Discussion

Discussion of a report published in the November 1998 issue of *Concrete International*, pp. S1-S90.

Proposed Revisions to Building Code Requirements for Structural Concrete (ACI 318-95) and Commentary – (ACI 318R-95)

Reported by ACI Committee 318

Fig. 1 Comparison of reinforcement spacing for slabs per 10.6.4 of 1995 and 1999 codes

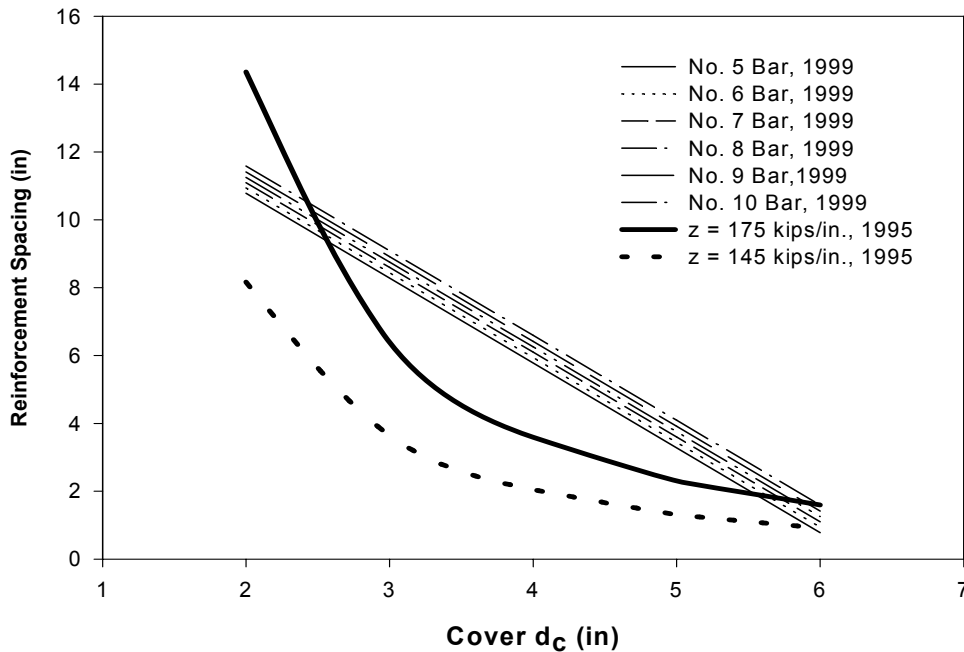
The new provisions significantly relax the spacing requirements for covers between 2 in. and 4 in. [Fig. 1] when compared to the current provisions. The new method, however, does not distinguish between different exposure conditions. The required spacing for crack control is independent of the exposure condition. This results in significant difference in spacing between the current and the new procedure for elements exposed to severe exposure (see Fig. 1, $z = 145$ kips/in). This is a rather drastic change. In essence, the new provisions suggest that exposure condition has no bearing on the required reinforcement spacing for crack control. Since corrosion should be somewhat exposure sensitive, does this also mean that spacing of reinforcement has no relation to corrosion?

The question also arises whether the new provisions are geared for corrosion resistance. The 1995 provisions were somewhat explicit in this by including the terms such as inside (mild) exposure ($z = 175$ kips/in.) and outside (severe) exposure ($z = 145$ kips/in.) that gave a sense that corrosion was being taken care of. The new provisions make no mention of the corrosion aspect at all. The reasons for change and the commentary 10.6.4 indicate that there is no relation between crack widths of 0.016 in. and 0.013 in. used previously for the two exposure conditions and corrosion. The new provisions, however, are still based on the crack width of 0.016 in. as stated in Reason 2. It follows that by limiting the crack width to 0.016 in., perhaps, the new provisions are geared more for preserving the appearance of concrete [Reference 1]. The background literature [References 2, 3] suggest that if crack widths are limited to 0.016 in., it should result in good corrosion protection. If this crack width is to be maintained despite the cover thickness, the concept is essentially the same as used previously. Why is it then said that corrosion has no relation to the crack width?

Professor Nawy and Dr. Munshi discussed the new 10.6.4. Some of their comments may be answered by the reason for change statement published with the proposed changes. Committee 318 believes that it is misleading to purport to calculate crack widths, given the inherent variability in cracking. The three important parameters in flexural cracking are steel stress, cover, and bar spacing. Steel stress is the most important of the three, and most of the correlation between test results and crack width prediction formulas is correlated with steel stress. When the steel stress is held constant, there is very little correlation with the $\sqrt[3]{d_c A}$ parameter. This may be seen in Fig. 4b of Professor Nawy’s Reference 3. Although the Gergely-Lutz regression line is drawn through the scattered data, any other line would fit almost as well (actually, as poorly).

Figure R18.13.1 Anchorage zones

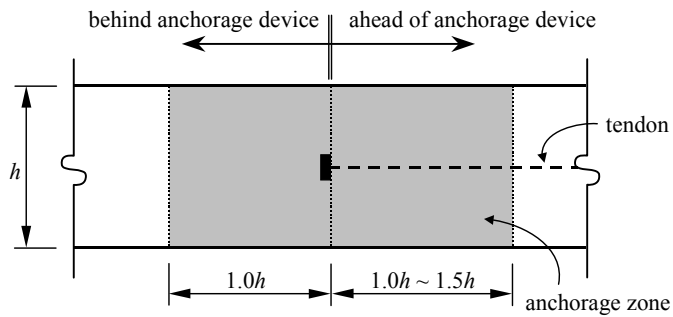
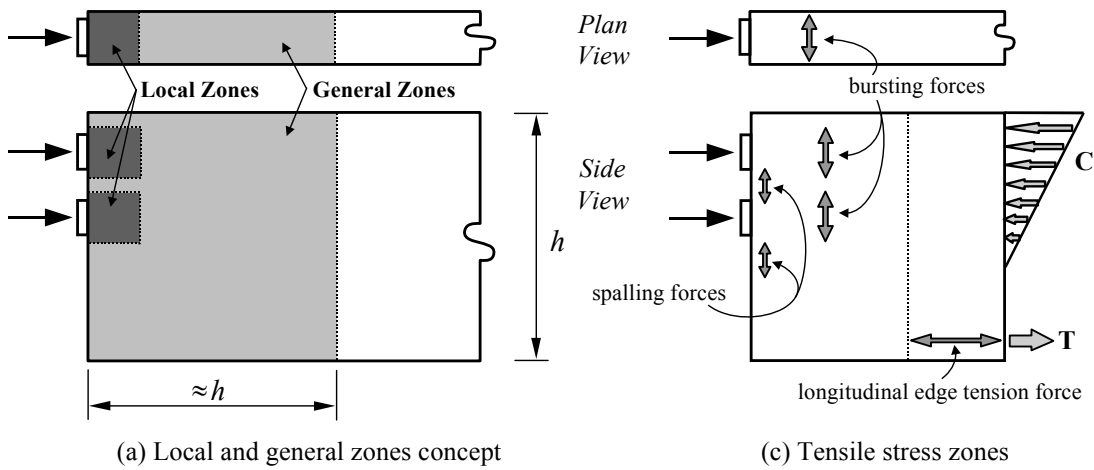
- It is confusing for the reader that neither Fig. R18.13.1 or Fig. R18.13.3 show information that explains the symbols of Eq. (18A) and (18B) the reader needs to refer to references 18X and 18Y. That situation is undesirable. A new Fig. R18.13.5 should be added to the Commentary. That figure should show all the quantities of Eq. (18A) and (18B) for an eccentric loading case.

The Committee thanks Professor Hawkins for his excellent comments. The Committee has redrawn Fig. R18.13.1, retitled Fig. R18.13.3 and added a new Fig. R18.13.5 for a tendon load with small eccentricity, all basically as suggested for improved clarity. Amendments are made accordingly.

Figure R18.13.3 Effect of cross-section change

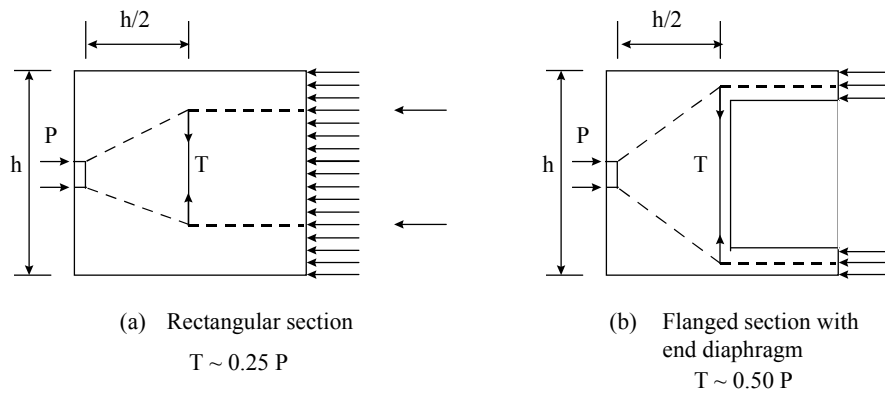
- Fig. R18.13.3 should be given a title: “Section Change Effect” is appropriate.
-

Figure R18.13.5 Strut and tie model example

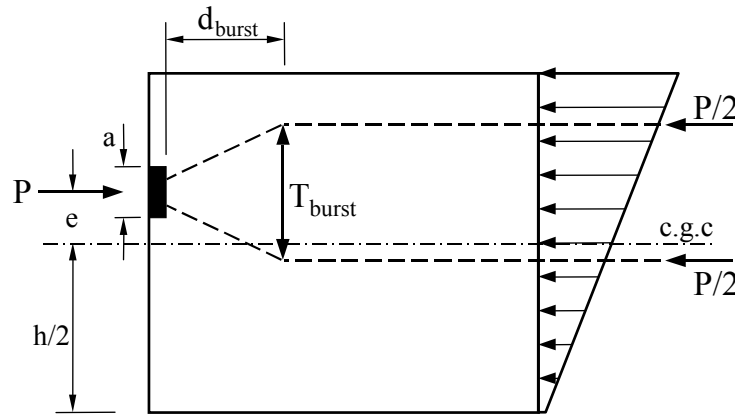
- To accommodate the inclusion of Fig. R18.13.5, Commentary Section R18.13.5 would need to be revised so that after the first sentence of the second paragraph the following sentence is added: “Meanings for the terms of Eq. (18A) and (18B) should be shown in Fig. R18.13.5 for a loading with small eccentricity.”
